P&Z CASE # SP2020-020 P&Z DATE 09/15/20 CC DATE _____ APPROVED/DENIED
ARCHITECTURAL REVIEW BOARD DATE _____ HPAB DATE _____ PARK BOARD DATE _____

08/20/2020: SP2020-020; PD Site Plan for PD-82 Terracina Estates

TO: Planning and Zoning Commission
DATE: September 15, 2020
APPLICANT: Todd Winters; *Engineering Concepts & Design, LP*
CASE NUMBER: SP2020-020; *Site Plan for Terracina Estates Subdivision, Phase 1*

PD SITE PLAN
Case No. SP2020-
TERRACINA ESTATES, PHASE 1
BEING
50.154 ACRES
SITUATED IN THE
JOHN A. RAMSEY SURVEY, A-186
CITY OF ROCKWALL
ROCKWALL COUNTY, TEXAS

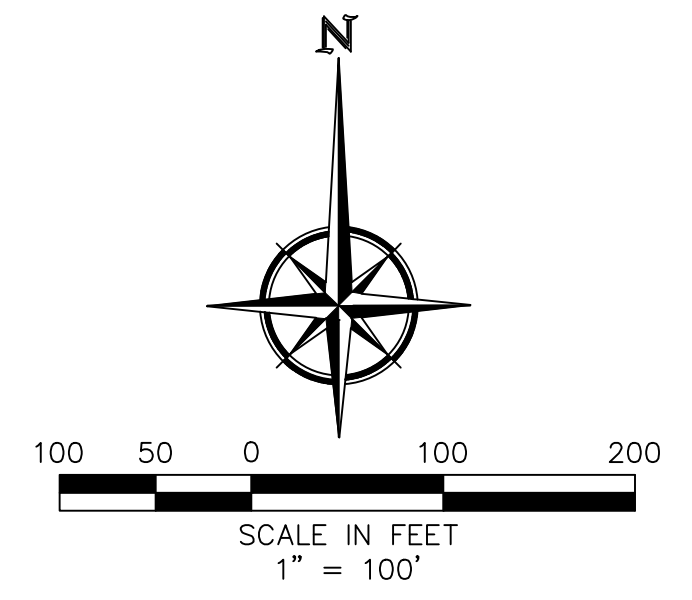
M.7 PD Site Plan. Please make the following clarifications on the site plan to ensure staff can properly review this project and convey all of the required elements to the City's boards and commissions (§03.04, Art. 11, UDC) and [Ordinance No. 18-08 (PD-82)]:

- 1) In the Site Plan Data Table (e), indicate Amenities within the Park. Also, will there be park benches provided? If so, please indicate. [Ordinance No. 18-08 (PD-82)]
- 2) In the Site Plan Data Table (g), indicate maximum height of 20-feet for street lights . [Ordinance No. 18-08 (PD-82)]

- 3) What is the hatched area within the park adjacent to Guadalupe Drive? Provide a label identifying this area or remove hatch. [Informational]
- 4) Use a lighter gray scale for the Bermuda grass as this is covering/hiding details that are not clearly visible on the plan. [Informational]

- 5) Indicate the locations for all neighborhood signage for the subdivision (i.e. entry feature). Final design and location of the entry features shall be reviewed and approved with the PD Site Plan. Provide entry signage detail plan. [Ordinance No. 18-08 (PD-82)]

- 6) Label and delineate the minimum 15-foot landscape buffer required along Rochelle Road. [Ordinance No. 18-08 (PD-82)]
- 7) Remove "Saddle Star South" from the Plant Legend. [Informational]

- 8) A minimum of four (4) inch caliper trees are required for the development. Correct plan. [Ordinance No. 18-08 (PD-82)]
- 9) Provide labels for all 'sidewalks' and 'trails' to better delineate their locations. [Ordinance No. 18-08 (PD-82)]

PD SITE PLAN
Case No. SP2020-020
TERRACINA ESTATES, PHASE 1
BEING
50.154 ACRES
SITUATED IN THE
JOHN A. RAMSEY SURVEY, A-186
CITY OF ROCKWALL
ROCKWALL COUNTY, TEXAS

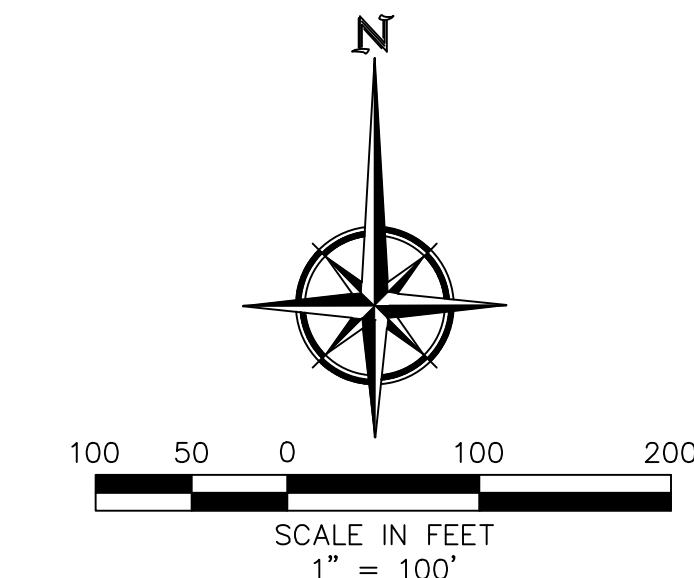
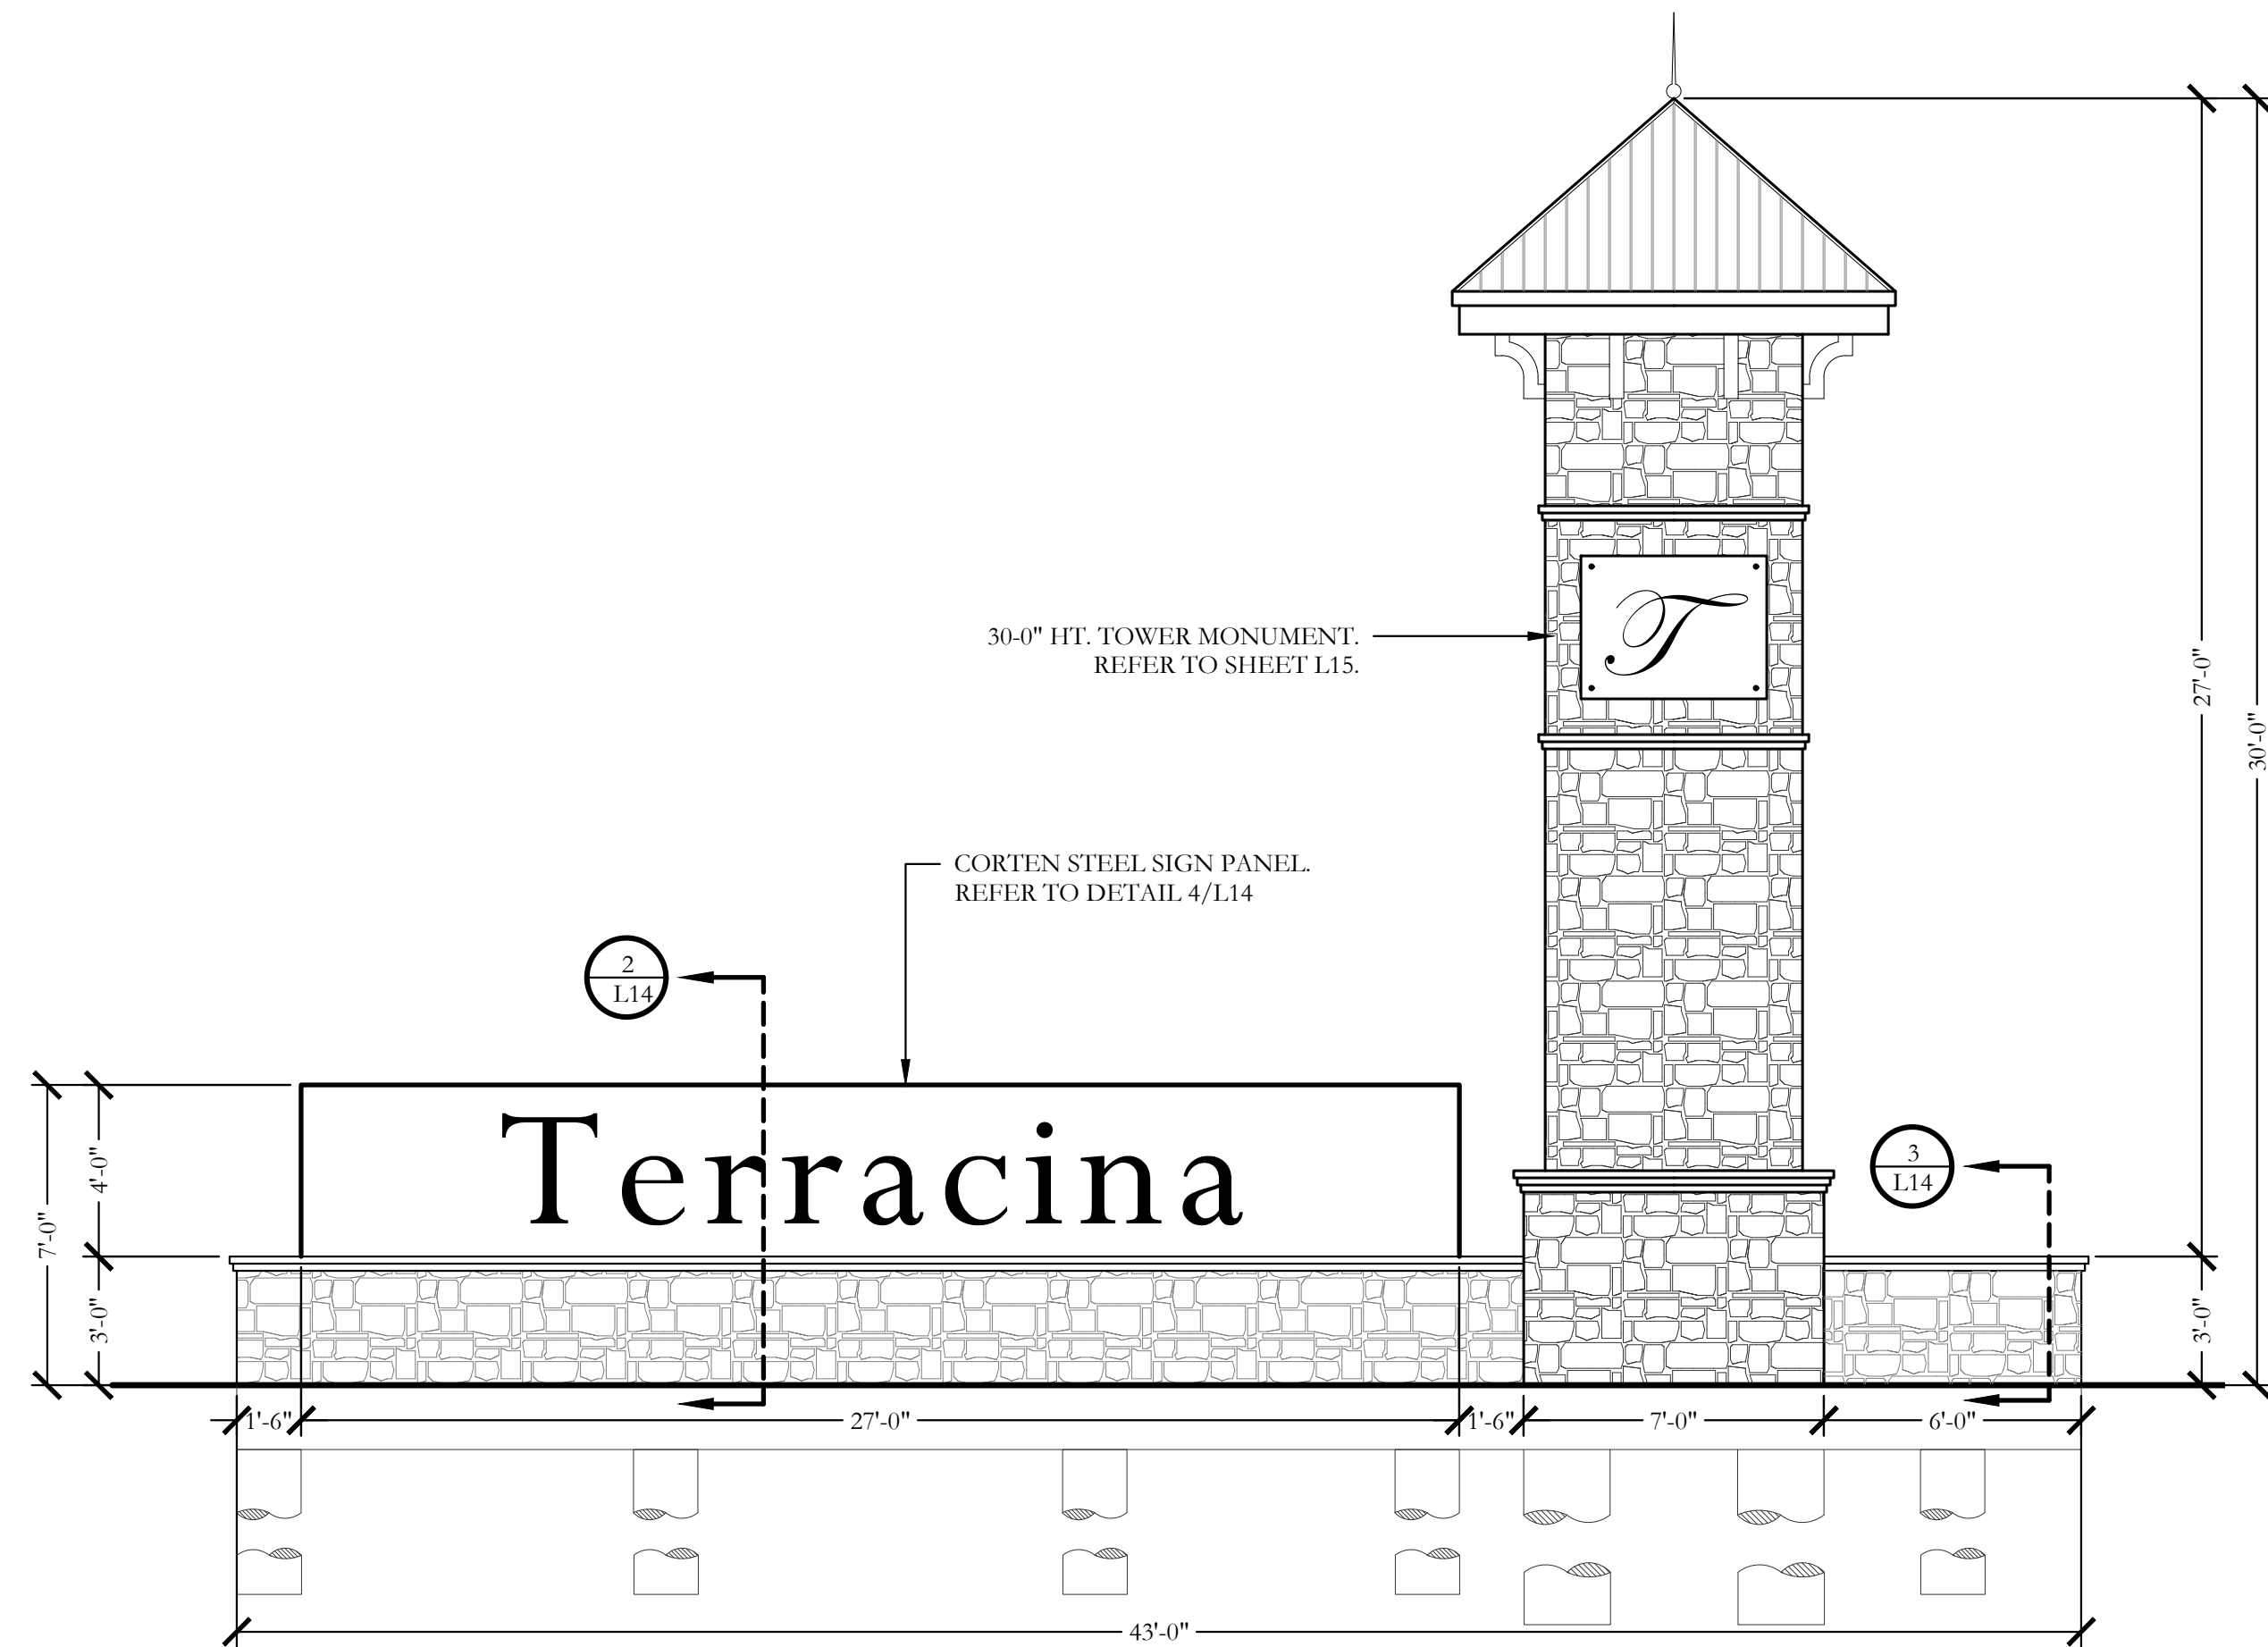
M.3 Landscape Plan: Please make the following clarifications on the landscape plan to ensure staff can properly review this project and convey all of the required elements to the City's boards and commissions (§03.04, Art. 11, UDC) and [Ordinance No. 18-08 (PD-82)]:

- 1) All canopy trees planted within the development are required to a minimum of 4" caliper.
- 2) All canopy trees are to be spaced at 50-ft centers. Verify spacing and number of trees planted.
- 3) Dimension and indicate the minimum 15-ft landscape buffer along Rochelle Road.
- 4) Indicate and label all signage for development (i.e. entry signs and park sign).
- 5) The concept plan approved with the zoning indicates two (2) layers of screening trees adjacent to the Timber Creek Subdivision.
- 6) Park equipment to be approved by the Parks and Recreations Department.
